RE: Phase 3 – Cells 1 and 2 Construction – **Response to Comments**
Avery County C&D Landfill
(NC Solid Waste Permit # 06-03)
Ingalls, North Carolina

ATTACHMENT A
Avery County C&D Landfill
Phases 1 and 2 Waste Volumes

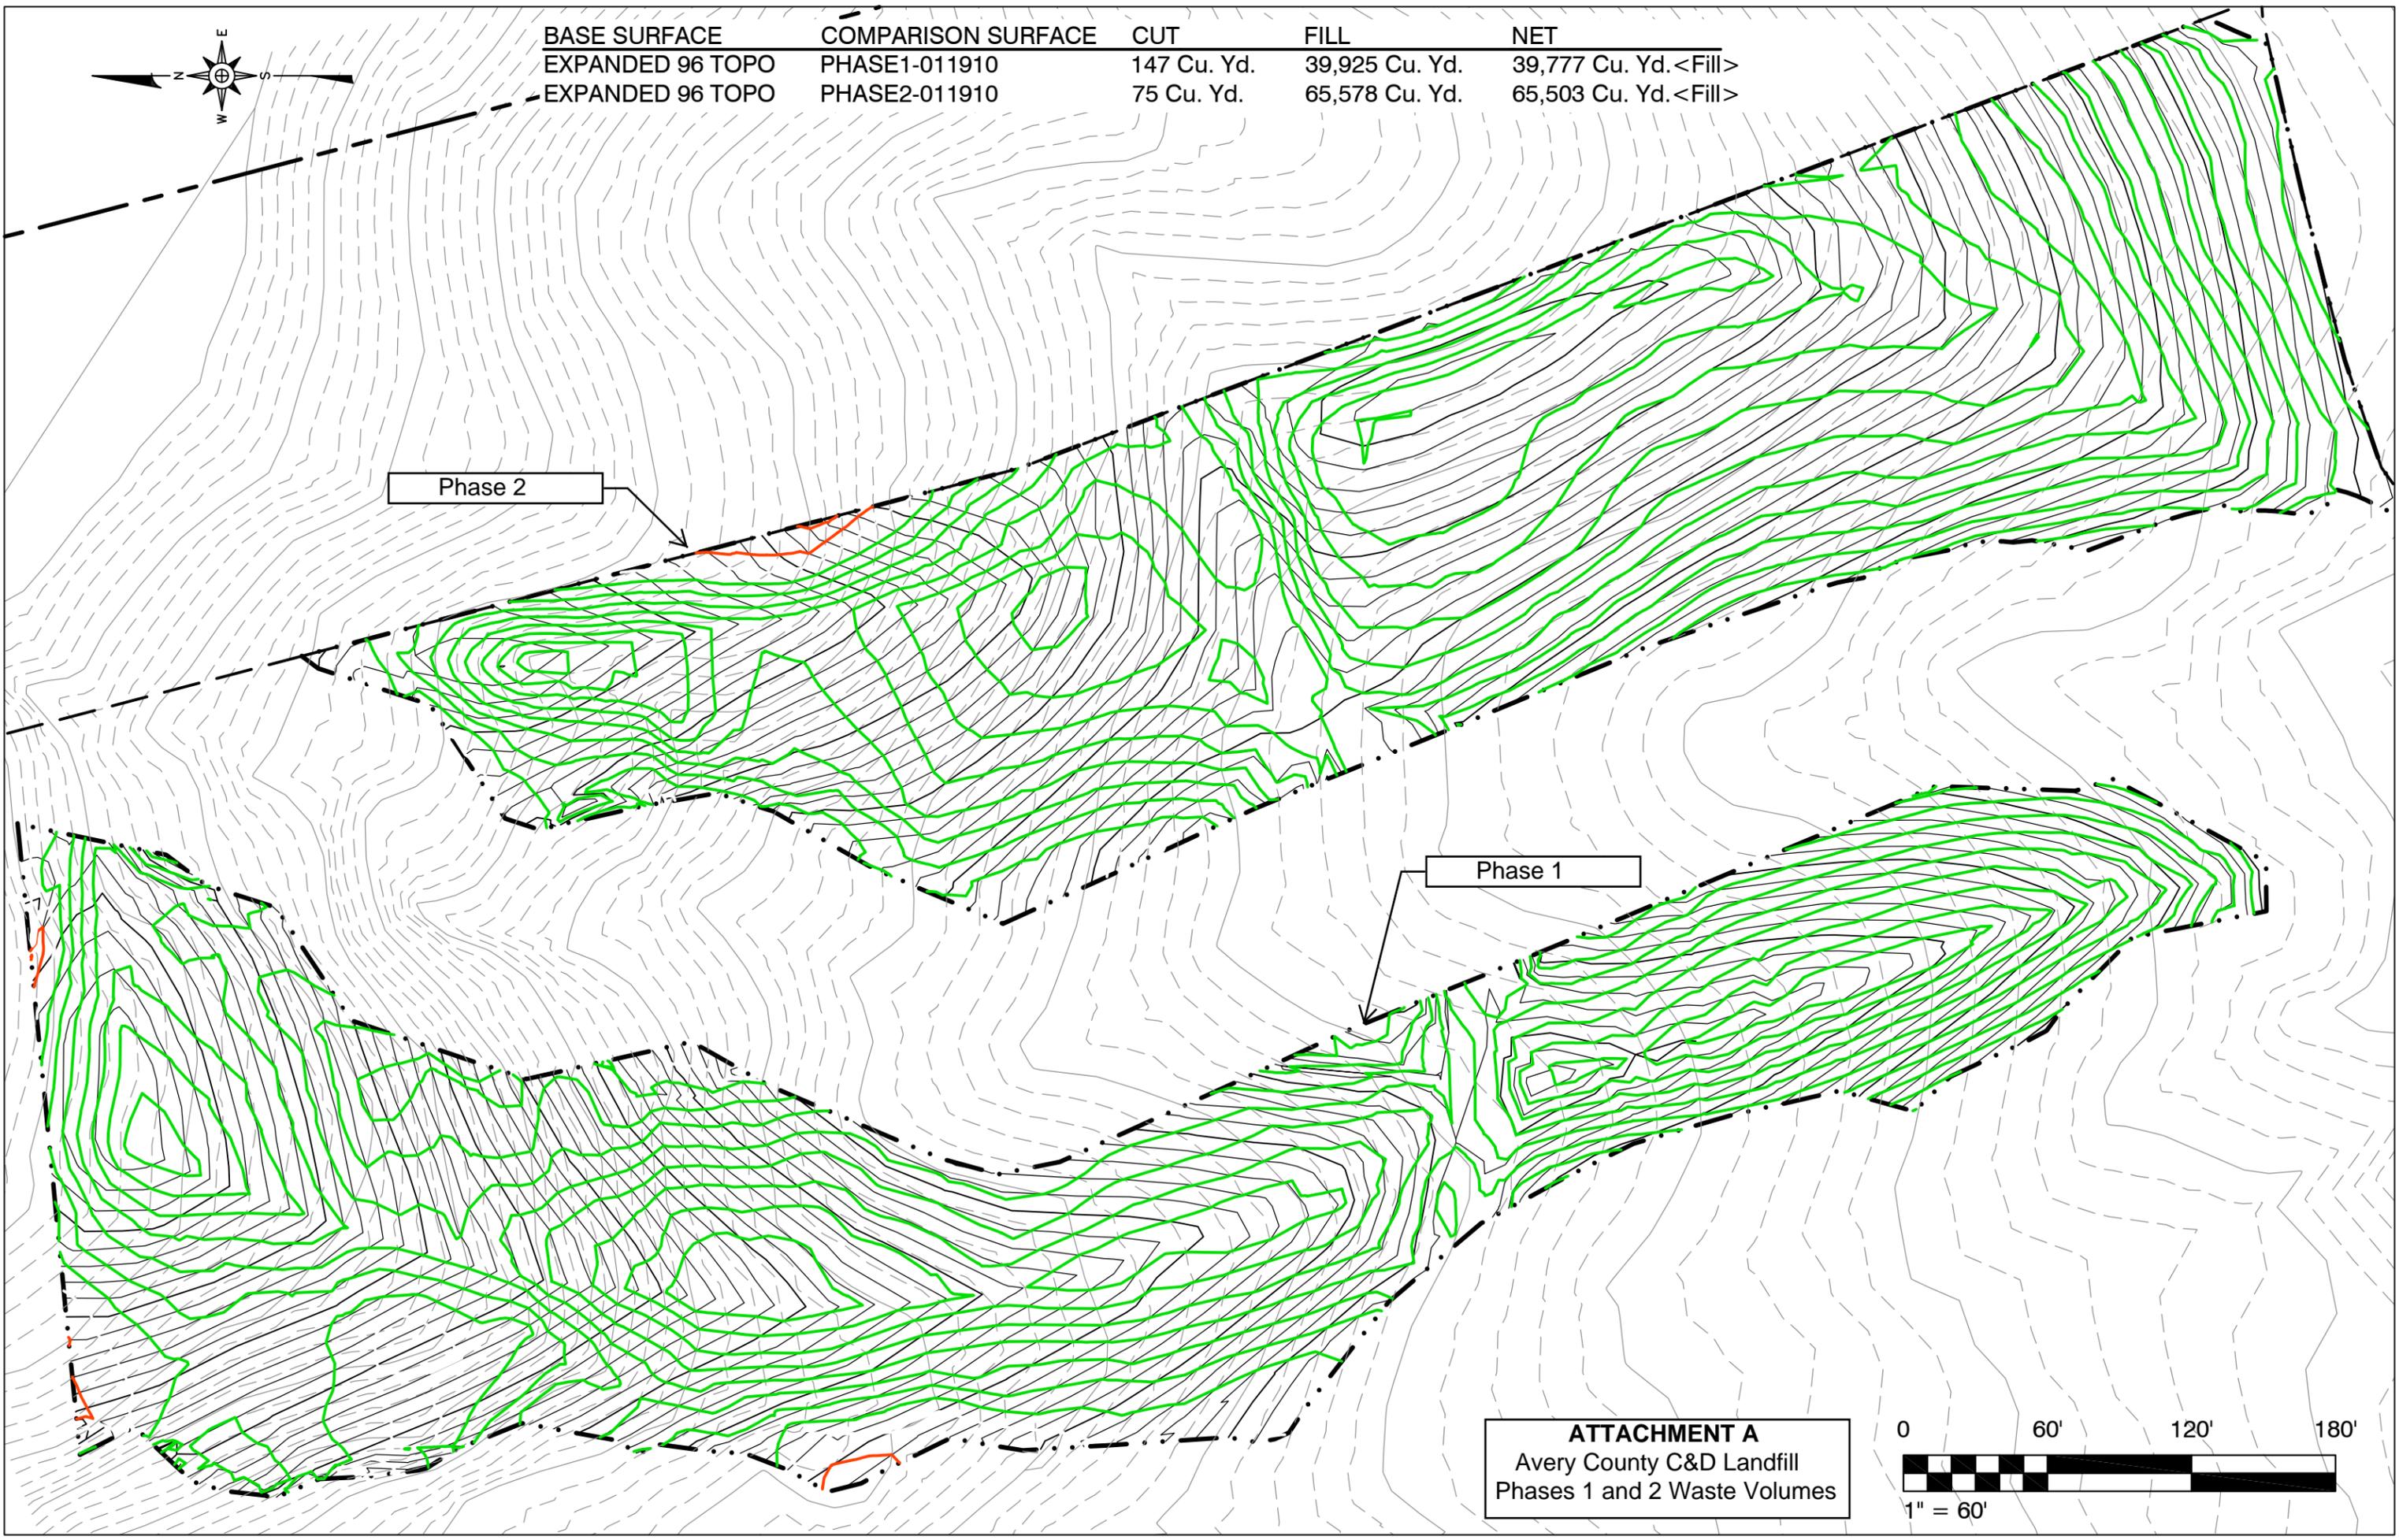
Provide volumes of waste placed, along with explanations, for Phases 1 and 2.

Response to Comment No. 2

A composite field topographic survey¹ of the existing Phases 1 & 2 of the C&D landfill,

including the vertical expansion grades² as well as the lateral expansion grades included in the Waste Relocation Plan³, was compared to historical drawings prepared by Municipal Engineering Services Company, P.A.. Electronic files for these drawings were not available. Therefore, RSG digitized the pre-development contours at a site specific datum from the permit application⁴ and translated the elevations to NC State Plane (~2,760 feet vertically). The comparison of grading yielded total volumes of waste in Phases 1 and 2 to be approximately 39,000 yd³ and 65,500 yd³ respectively, as shown in **Table 1**. It is understood that this quantity is approximate and is limited by the accuracy between the current survey data and the historical topographic files. However, it is our opinion that it is consistent with historical permit documents.

BASE SURFACE	COMPARISON SURFACE	CUT	FILL	NET
EXPANDED 96 TOPO	PHASE1-011910	147 Cu. Yd.	39,925 Cu. Yd.	39,777 Cu. Yd. <Fill>
EXPANDED 96 TOPO	PHASE2-011910	75 Cu. Yd.	65,578 Cu. Yd.	65,503 Cu. Yd. <Fill>
